STAFF REPORT
Site Plan Review

Docket No. SP-72-22
Chick-fil-A Restaurant

Variances to the area regulations, the landscape & buffer requirements, and the sign regulations of the Commercial Parkway Overlay Zone (CPZ) for a Chick-fil-A restaurant.

FIGURE 5

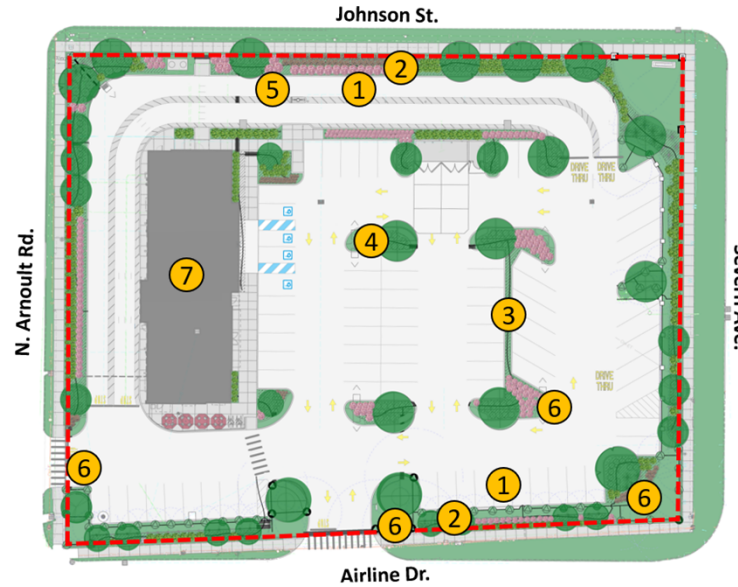
- The applicant proposes parking spaces and paving in the required front yards along both Airline Dr. and Johnson St., necessitating a variance to the CPZ area regulations (Figure 5).

5. The proposal includes the following requests for variances to the CPZ landscape & buffer requirements (Figure 5):
 - Per Sec. Sec. 40-474, no parking or paving shall be allowed in the required 20-ft. front yard except for sidewalks or approved driveways. The proposal includes parking in the required front yard along Airline Dr., and a drive-thru lane in the required front yard along Johnson St.

- Per Sec. 33-6.25.5.d.2.5, a five-ft.-wide parking planting strip is required every two parking aisles. The applicant proposes a three-ft.-wide parking planting strip.

- Per Sec. 33-6.25.6.b, a minimum 50% of the trees on site must be Class A trees. The applicant proposes 29.6% Class A trees.

7. Per Sec 40-477(b)(7) one menu board is permitted per drive-thru lane which must be located in a landscaped bed. The site as proposed contains two drive-thru lanes and two menu boards. Only one of the boards is located in a landscaped bed however, necessitating a variance to the landscape regulations for the location of the second menu board (Figures 5 & 6) (Table 3).

Variations			
	Regulation	Required/Allowed	Proposed
1	40-474.a.1	No parking or paving allowed in the required front yard except for sidewalks or approved driveways	Parking/paving in both required front yards.
2	33-6.25.5	20-ft. streetscape front planting buffer along the Airline Dr. and the Johnson St. rights-of-way.	10.5-ft. streetscape front planting buffers along both street frontages.
3	33-6.25.5.d.2.5	5-ft.-wide parking planting strip every two parking aisles.	3-ft.-wide parking planting strip.
4	33-6.25.6.b	50% minimum Class A trees.	29.6% Class A trees.
5		Landscaping required for menu boards	No landscaping
6	40-477(b)	Number of detached signs – allowed 2	4
7		Number of attached signs – allowed 2	4

FIGURE 6

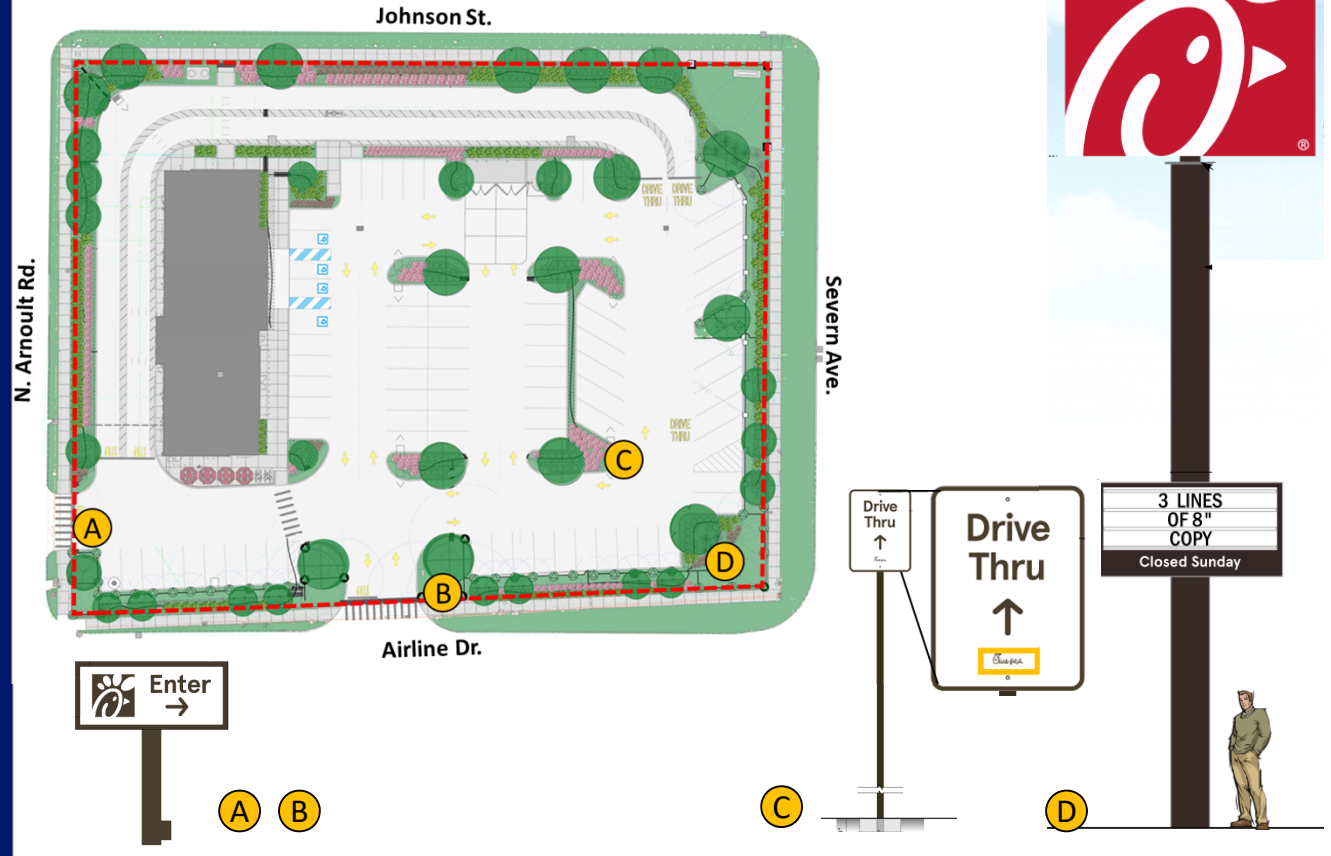
6. Per Sec. 40-477(b) sites are permitted one detached sign however corner and through lots are also permitted a second detached sign. As such, the lot is permitted a total of two detached signs. The applicant also proposes four detached signs. The first detached sign the applicant is proposing is one pole sign located in the southeast corner of the site near Airline Dr. and Severn Ave. This sign meets the CPZ requirements. The remaining three detached signs were initially identified as directional signs, however the inclusion of the logo and business name on them results in their reclassification as detached signs, necessitating a variance to the CPZ sign regulations for the number of detached signs (Figures 5 & 6) (Table 3).

Variances			
Regulation	Required/Allowed	Proposed	
6	40-477(b)	Number of detached signs – allowed 2	4
